West Midlands Interchange

Application Statement for Proposed Non-Material Change

West Midlands Rail Freight Interchange Order 2020 (as amended)

June 2023

Extension of Zone C to north of Rail Terminal for Double Track Under Bridge No.1 (as consented)

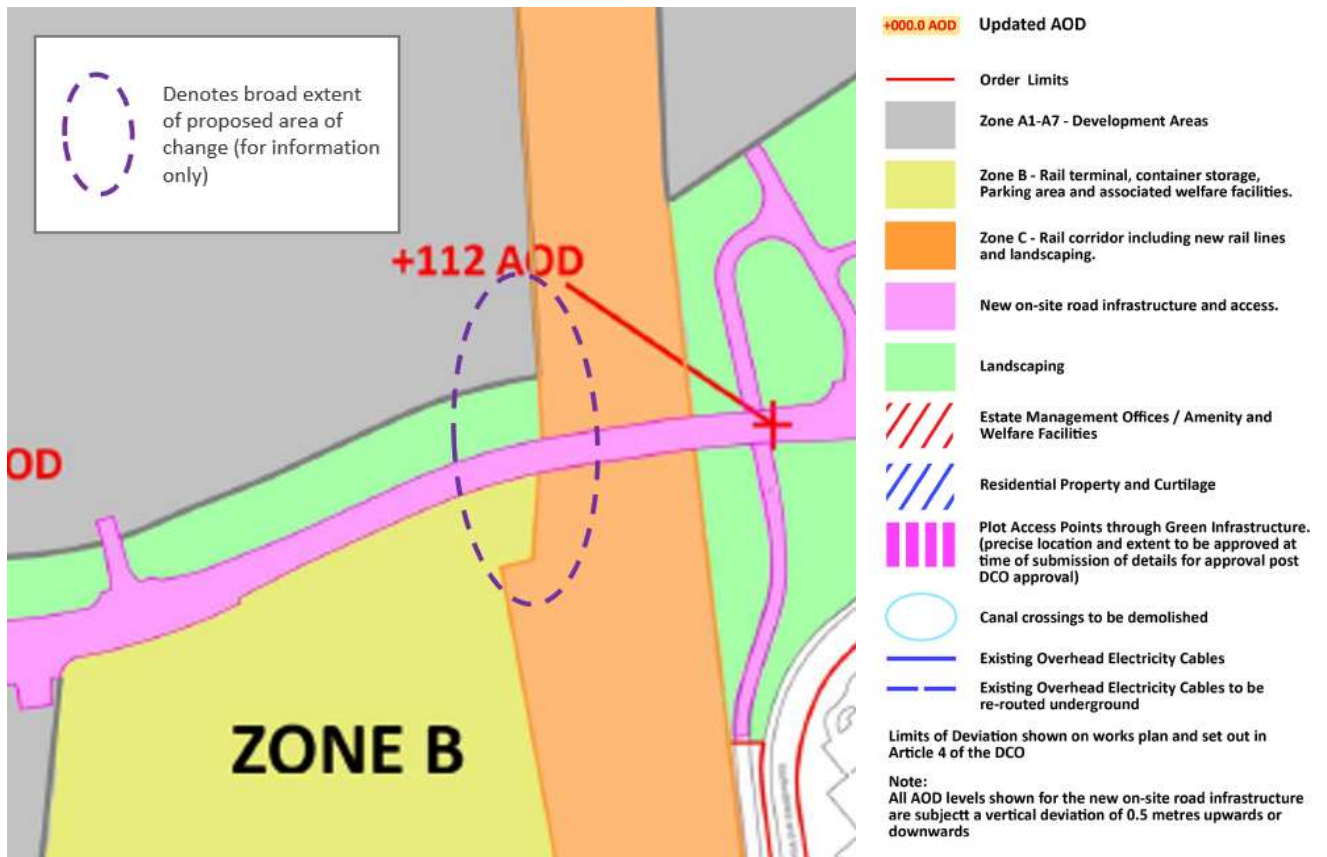
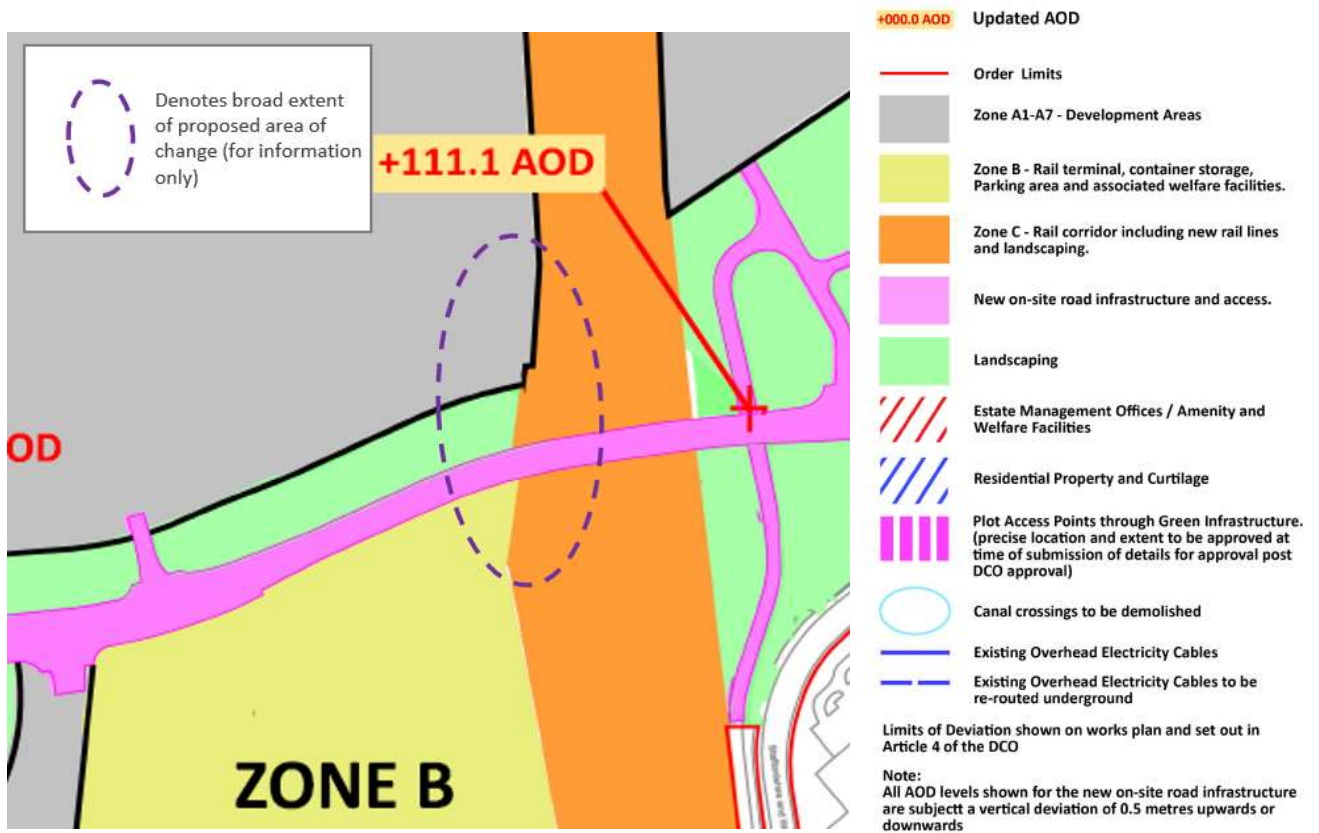
59. The certified Development Zone, Floor Levels and Building Heights and Green Infrastructure Parameters Plans as described at paragraph 54 identify the extent of the rail corridor, including new rail lines and landscaping, as Zone C. Zone C enables the connection of the new rail lines serving the Rail Terminal to connect to the WCML Loop railway to the north of the A5/A449 Link Road (Bridge No.1).

60. The Applicant requires additional land to be incorporated into the northern part of Zone C (Works No.1), comprising 1,129sqm / 0.129ha.
61. This land is currently identified on the certified Development Zone, Floor Levels and Building Heights and Green Infrastructure Parameters Plans as Rail Served Warehousing (Works No. 3) and Landscaping (Works No.6). This would result in a net reduction in area for Landscaping by 347sqm / 0.0347ha, for Rail Freight Infrastructure by 418sqm / 0.0418ha, for highways infrastructure (Works No. 4) by 172sqm / 0.0172 ha, and for Rail Served Warehousing by 192sqm / 0.0192ha. This reduction in Rail Served Warehousing area does not affect the ability to deliver the maximum quantum of floorspace identified on the certified Development Zone Parameters Plan (Certified Document No.2.5). This change, which includes a reduction area for landscaping, has been considered in the Environmental Implications Report which concludes that no new or different significant environmental effects will arise as a result of this (or any other) change.

62. The proposed amendment is facilitated by the proposed change to the width of Bridge No.2 span, which is detailed at Section 2 of this Statement.
63. The Illustrative Arrangement of Railway Alignment (Certified Document No. 2.14, (Drawing No. TRS-DRG-FA-001003 Rev 3)) shows the proposed arrangement of the new rail lines including connection to the WCML Loop railway. In order to capture the northward extension of Zone C described above, a revised Illustrative Arrangement of Railway Alignment is submitted with this Application. This is also reflected on the revised Bridge Plans (Certified Document Nos. 2.18A “Proposed road bridges plan and long section”, (Drawing No. 2.18A, 1516-04250WDK-SI-C-301-010 Rev P8), and 2.18B “Proposed Bridge B1 Section and Elevation”, (Drawing No. 1516-04250WDK-SI-C-301-006 Rev P11), and Works Plans (Certified Document Nos. 2.2 “Key Plan, 2.2, Key Plan v1”, and 2.2B “Sheet 2 of 9 v1”).

General arrangement (as consented)

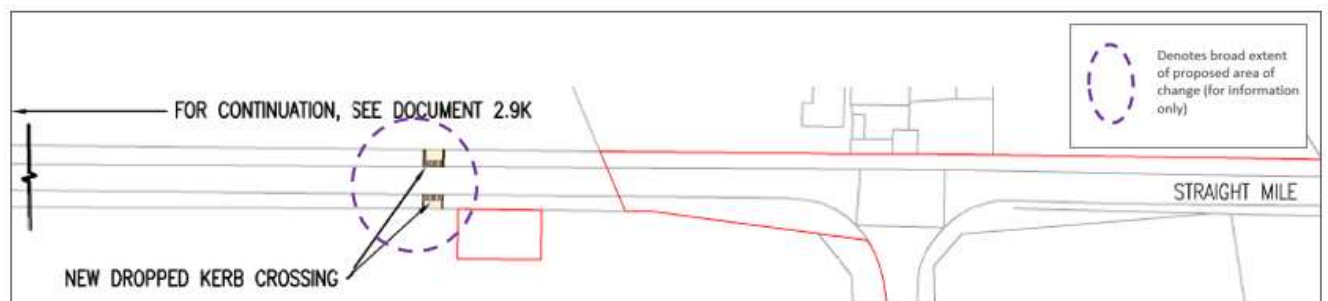
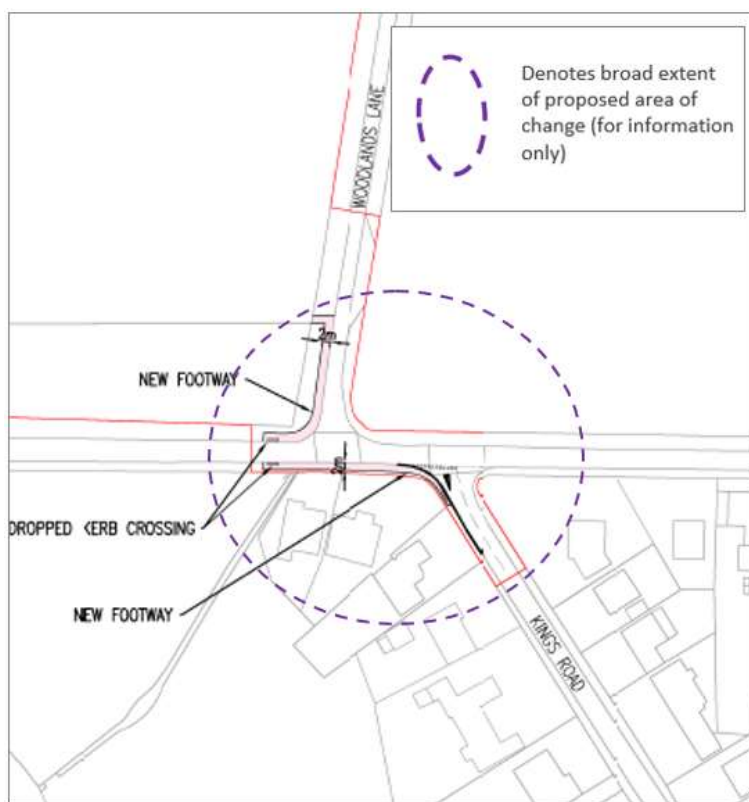
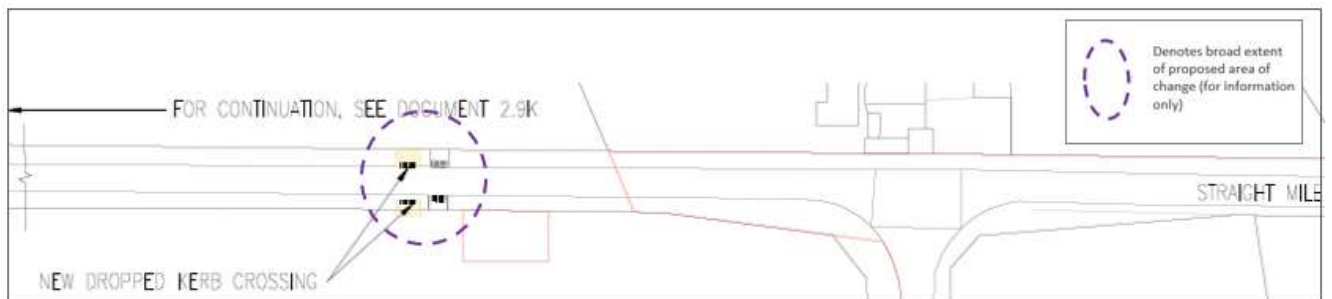
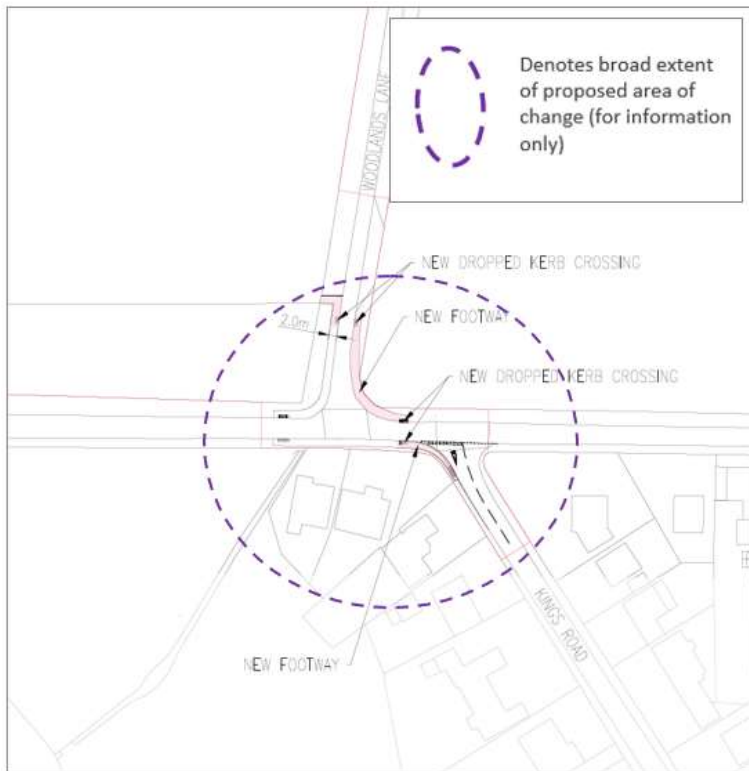
71. It is proposed that a new dropped kerb crossing would be formed on the eastern side of Woodlands Lane, allowing crossing from proposed Calf Heath Community Park, leading to a new footway along the eastern side of Woodlands Lane down to Straight Mile, where a dropped kerb crossing would allow pedestrians to cross to the new footway on Kings Road. This would remove the need for circa 35m of footway on the southern side of Straight Mile. These footway changes require amendment to Certified Document No. 2.9K "Highways General Arrangement Plan 111" (Drawing No. WSP-70001979-GA-111 Rev G).

- Detailed design development has confirmed that it is no longer feasible to deliver the new dropped kerb crossing in its current consented location on Straight Mile. This is proposed to be moved approximately 15 metres westward. This is because a vehicle layby providing maintenance access to a statutory undertaker’s inspection chamber has been constructed since the preparation of the Highway General Arrangement Plan that illustrates these highway works. This recently added layby would prevent the crossing point being introduced as approved. The repositioned crossing point responds to the changes in the highway network and remains as safe and as convenient as the current approved location; and,

75. The amended Straight Mile / Kings Road / Woodlands Lane crossing would provide an equally safe and convenient crossing of Straight Mile for those residents of Calf Heath compared to the currently consented arrangement, including for persons wishing to walk to and from the Calf Heath Community Park. The amended crossing would be provided in a form which is comparable to the current approved highway works in this location which will ensure that the route is provided as intended by the approved arrangements. Woodlands Lane is a lightly trafficked part of the local highway network and introducing a pedestrian crossing would not give rise to any highway safety issues for the travelling public.
